Edwin I. Hatch Nuclear Plant - Unit 1
Response to Request for Additional Information on
Request to Revise Technical Specifications:
Safety Limit Minimum Critical Power Ratios (SLMCPR)

Nonproprietary Version of the RAI response

Responses to REQUEST FOR ADDITIONAL INFORMATION
RELATING TO AMENDMENT NO. TO LICENSE NO. DPR-57
SOUTHERN NUCLEAR OPERATING COMPANY
EDWIN I. HATCH NUCLEAR PLANT, UNIT 1
DOCKET NO. 50-321

Figure 1 Reference Core Loading Pattern – Cycle 20

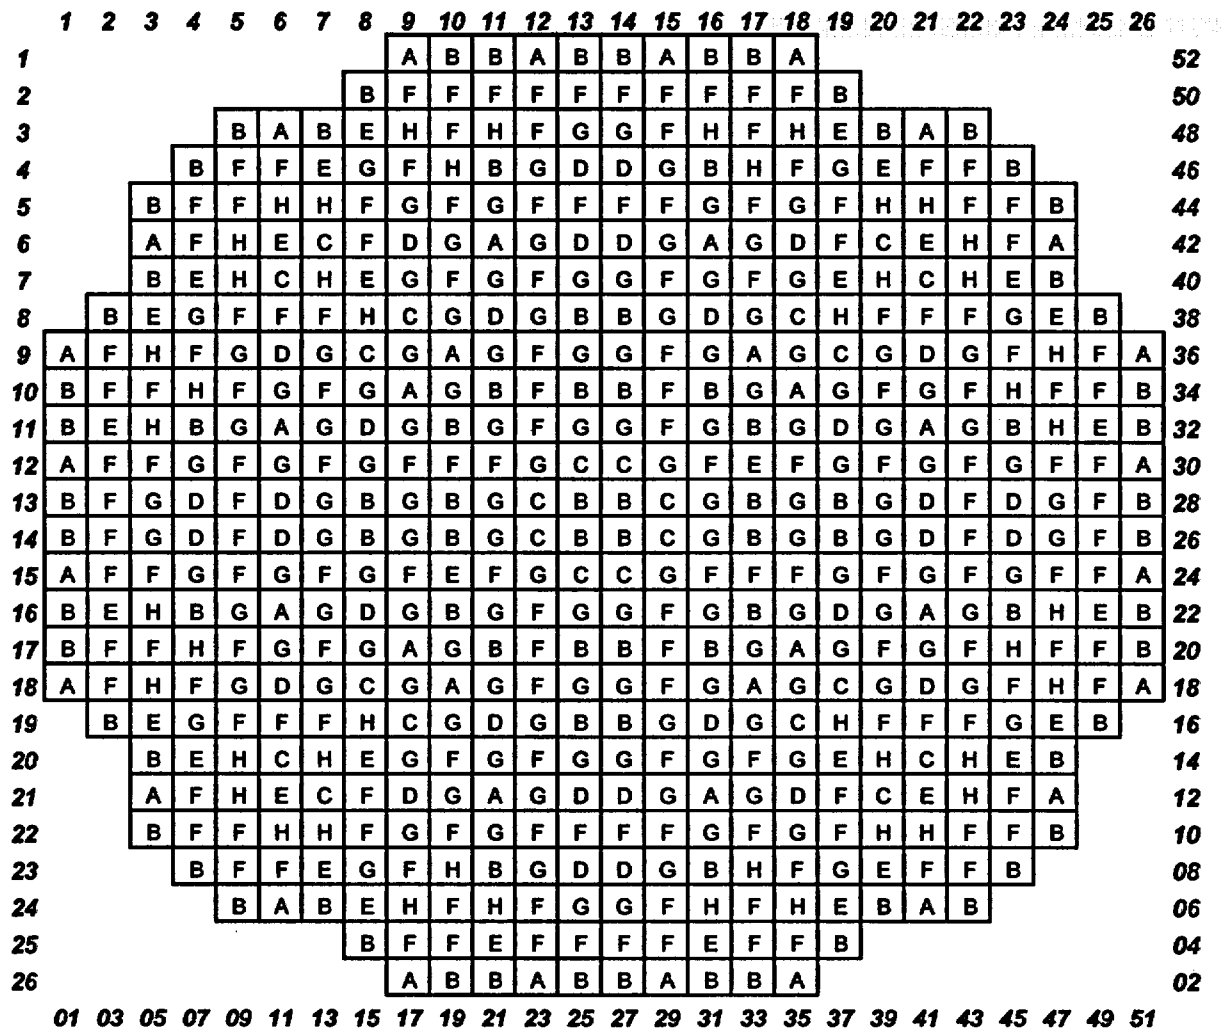
1. Figures 1 and 2 for Cycle 20 and Cycle 21 Reference Core Loading Pattern, respectively, should be updated to include quantity of fuel assemblies, and when those assemblies are loaded in the core.

Updated figures of the core loading patterns are provided which include the quantity of fuel assemblies and the cycle in which those assemblies were first loaded in the core.
